ALERT SERVICE BULLETIN

REPLACEMENT OF FUEL PUMP

FOR ROTAX[®] ENGINE TYPE 912 (SERIES) SB-912-053

(see Fig.1)

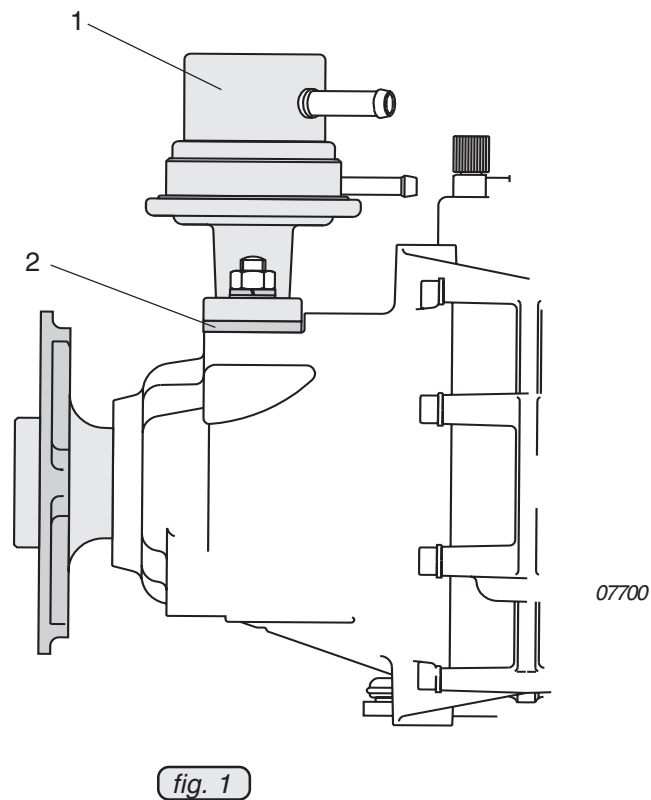
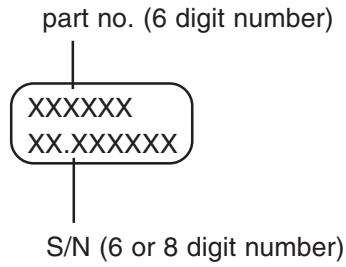
1. Remove fuel pump (1).
2. Gasket (2) replaced by new part.

■ **CAUTION:** Install new gasket supplied with new fuel pump. The thickness is different.

3. Install fuel pump. Tightening torque 15 Nm (133 in.lb).
4. Install fuel line.

Replacement of fuel pumps with part no. 892230, 892232, 892540 through part no. 892542 and Replacement of fuel pumps with part no. 892235, 892236, 892545 through part no. 892546 for ROTAX[®] engine type 912 (Series).
